MEMORANDUM

DATE: June 16, 2015

SUBJECT: BZA Case 19020, 1011 K Street, N.W.

T. OFFICE OF PLANNING RECOMMENDATION

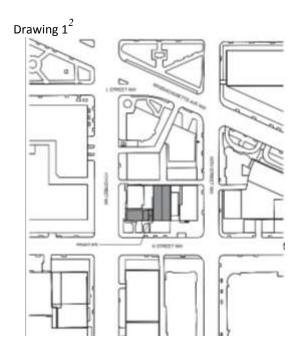
The north wall of the proposed building, proposed to be approximately 50 feet in width, would be located along a twelve-foot wide east/west alley that was functionally widened from twelve feet to twenty feet through the dedication of an easement, as shown on Drawing 1 below. The proposed building is also located directly across from where the north/south alley within the square intersects with the east/west alley. As a result approximately 41 percent of the rear of the building would be across an alley, and not an office or apartment building. In
